Six Chuter Inc.
SAFETY DIRECTIVE

LEVEL	MANDATORY
DATE	08/01/2008
SB NUMBER	SB 2008-01
APPLICABLE MODELS & CATEGORIES	XT ssdc

- 1.3.1 Failure of welds on XT canopy steering bars

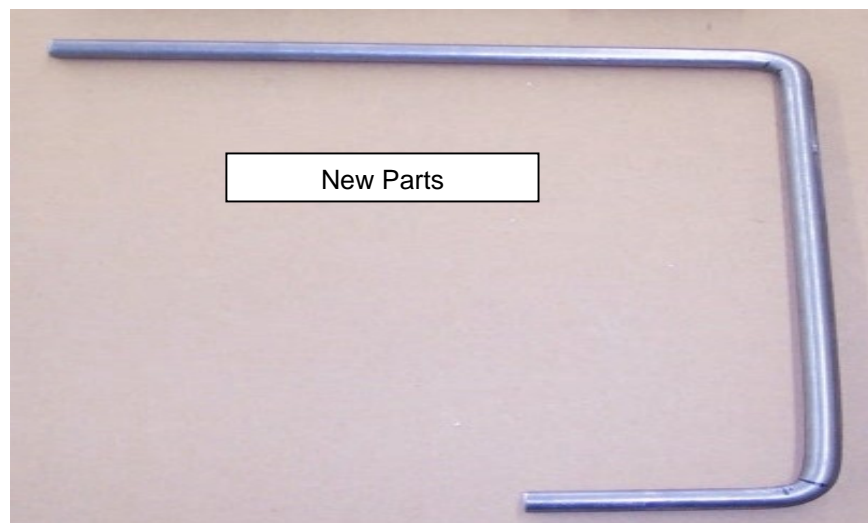
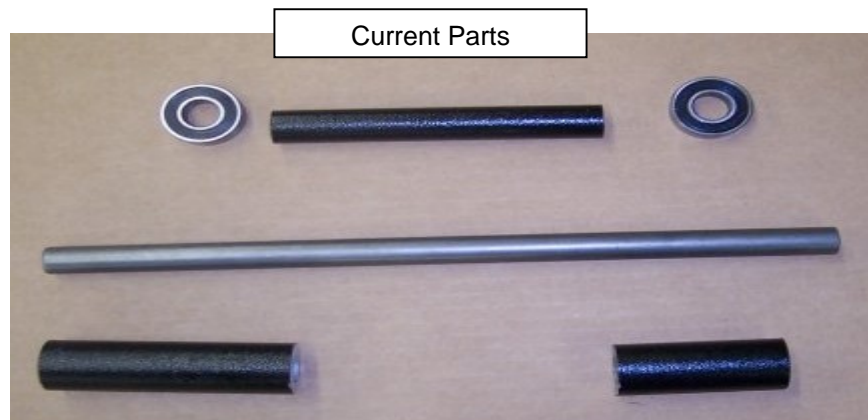
- 1.4.1 Two aircraft have experienced breaks on the welds of the inboard pedals. This resulted in difficulty controlling the aircraft from the side of the aircraft where the weld broke.

- 1.5.1 By making the foot bar one piece, it eliminates the weld and when in its' final assembly position and pinned ties both sides together in a solid assembly and eliminates the possibility of failures such as experienced. The shorter foot bar that is welded into the long side tube can also be changed to a threaded bar that runs through the tube and is secured on both sides of the tube with nuts thus eliminating that weld as well. A field repair on current units would require removing the foot bars from the unit. Removing the pins that hold the assembly together and then reinstalling a new "one piece" foot bar into the assembly and re-pinning. This would not include any change to the short foot bar on the long tube.
